January 13, 2015

Re: Design Progression – Final UDC
3204 Golden Copper Lane
Maple Grove Commons
Madison, WI
KBA Project #1355

Re: Letter of Intent – Final UDC Application
Maple Grove Commons
Madison, WI
KBA Project # 1355

3204 & 3228 Golden Copper Ln.
Madison, WI
SHEET TITLE
SITE PLAN

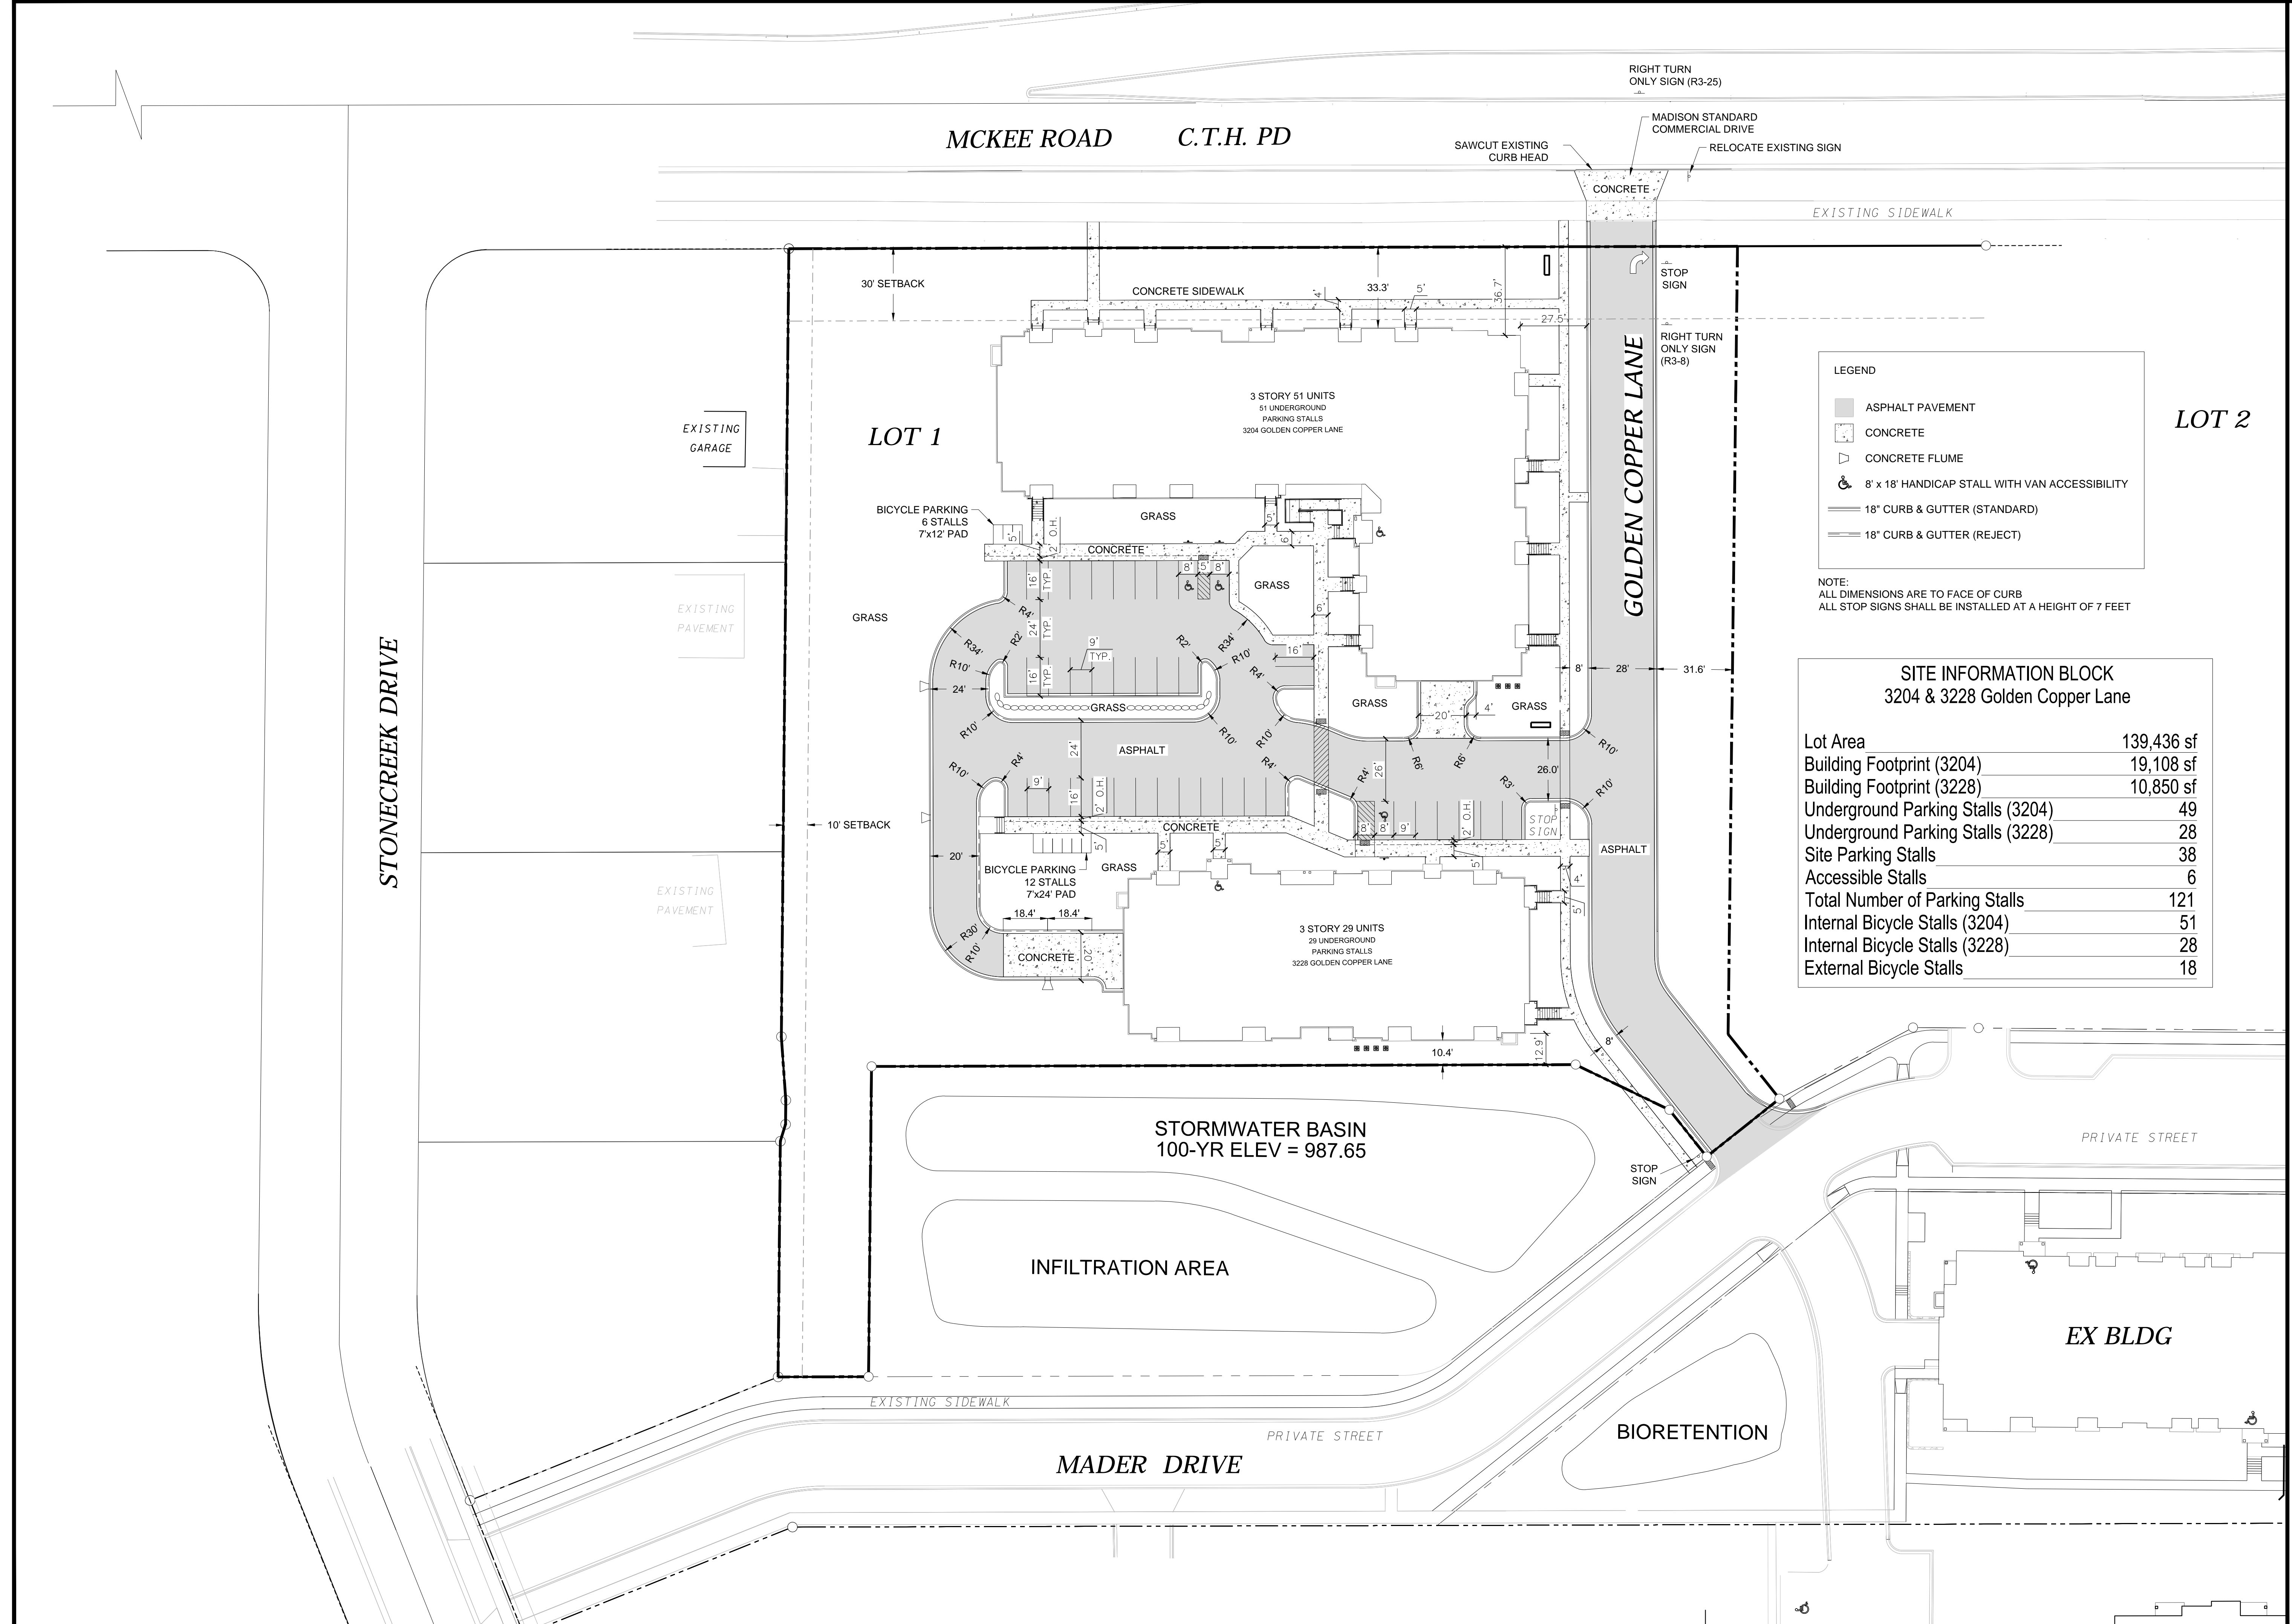
- The concrete plaza adjacent to the community room at 3228 Golden Copper Lane (Building B) has been removed.
- The grading around Building B has been revised.

LANDSCAPE PLAN

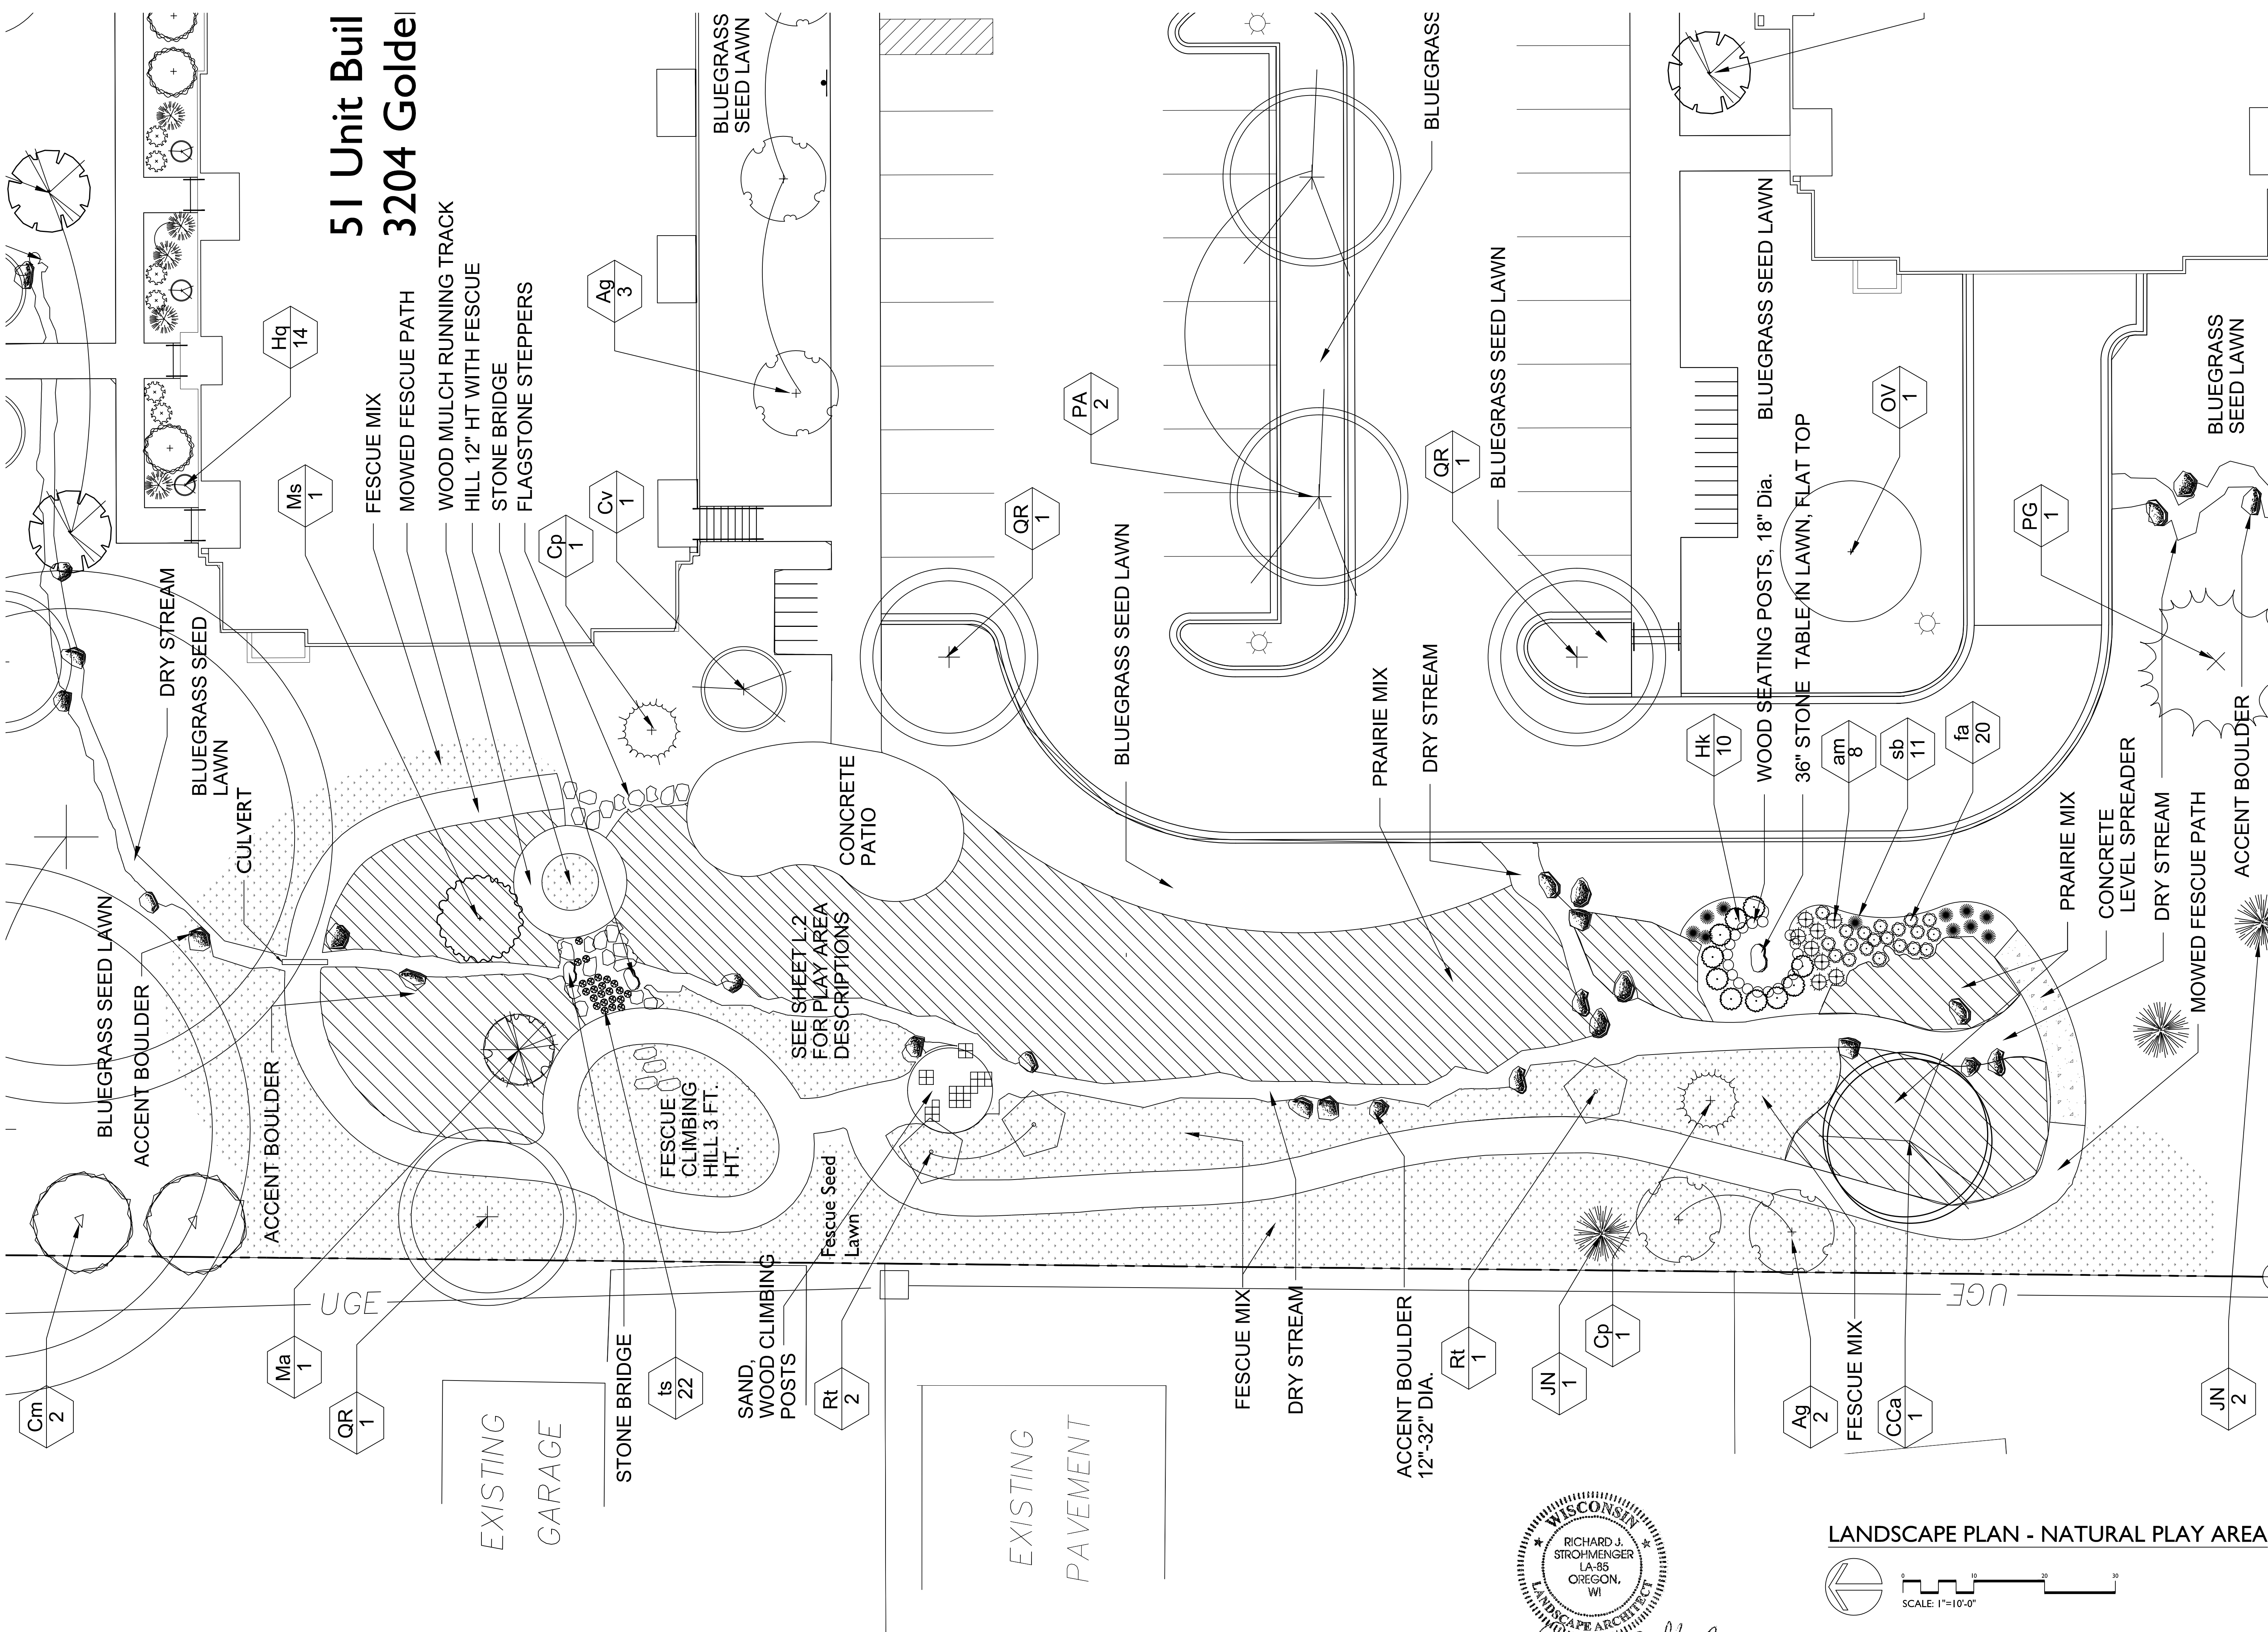
- Plants highlighted on the landscape plan will be removed. Remaining plants will be distributed evenly to fill in the site. The landscaping requirements will still be met after the highlighted plants are removed.
